Cherhill New Village Hall CRTBO Consultation Statement

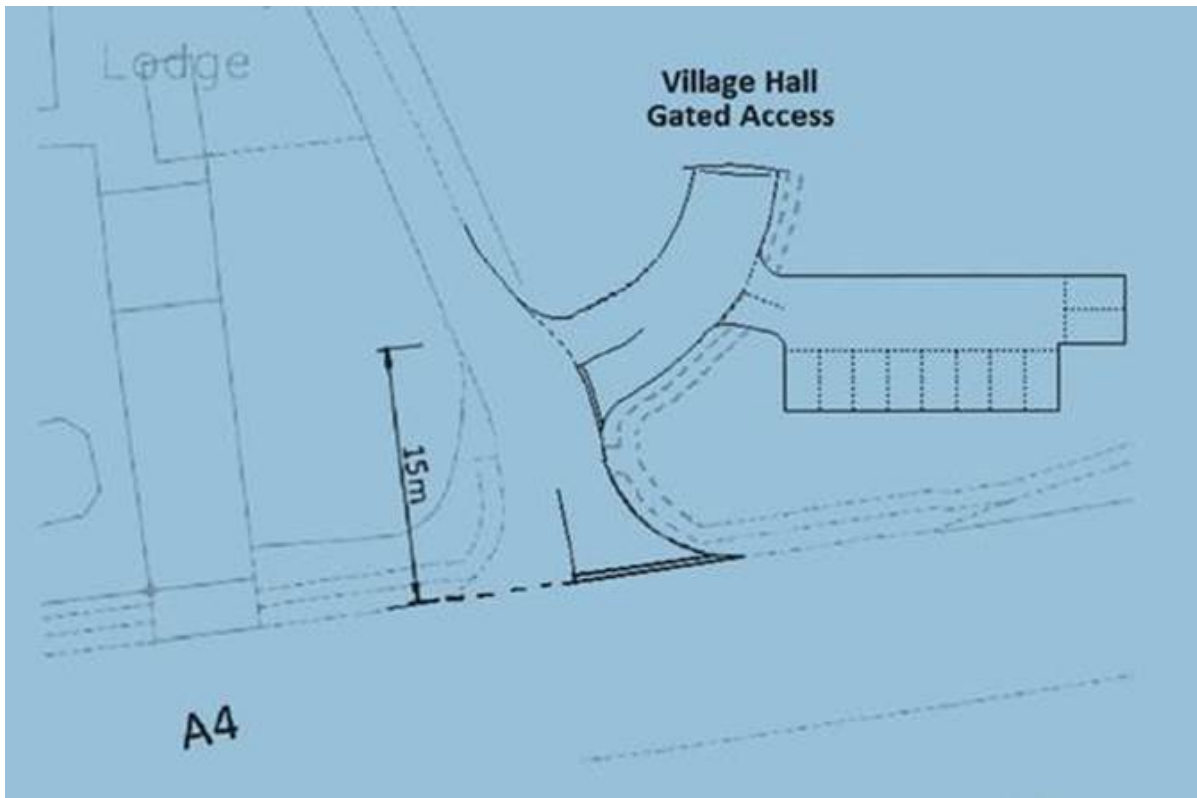
Respondent 23 has suggested moving the location of the entrance nearer to the A4 junction to reduce the length of widened road and consequently the risk of people parking in the widened lane. The following sketch has been provided :-

Traffic in Park Lane has always been treated as an important consideration in part because it has been a recurring theme in the various consultation stages. For those reasons the services of a transport consultant were employed and advice was sought from Wiltshire Council Highways Department. Both offered the same advice - that the existing entrance opposite the location to Oldbury Fields was the best. It is a safe distance from the A4 junction and minimises the chance of car headlights shining into the homes opposite at night. Having received the above suggestion Wiltshire Council Highways Department were consulted once more and the following email was received:-

“Having considered the below I am minded to adhere to the professional highway advice in terms of access location. 15m from a main junction is not acceptable and would encourage conflicting vehicle movements in very close proximity to a priority junction. Though I note the gentleman’s suggestion that a footpath will encourage on street parking it is my opinion that the best way to accommodate visitors parking is within the site so every effort should be made to make sure that parking meets the required standards. If you are minded to accommodate other resident’s comments it may be possible to consider an access slightly further south than from the one proposed but it should be located at a minimum distance of 33m from the junction.”

The entrance could be moved a little further south but that is unlikely to make any difference to the chance of people parking in the road and as mentioned above runs the risk of car headlights affecting the house opposite. The concerns about parking in Park Lane are taken seriously and the following steps are proposed:
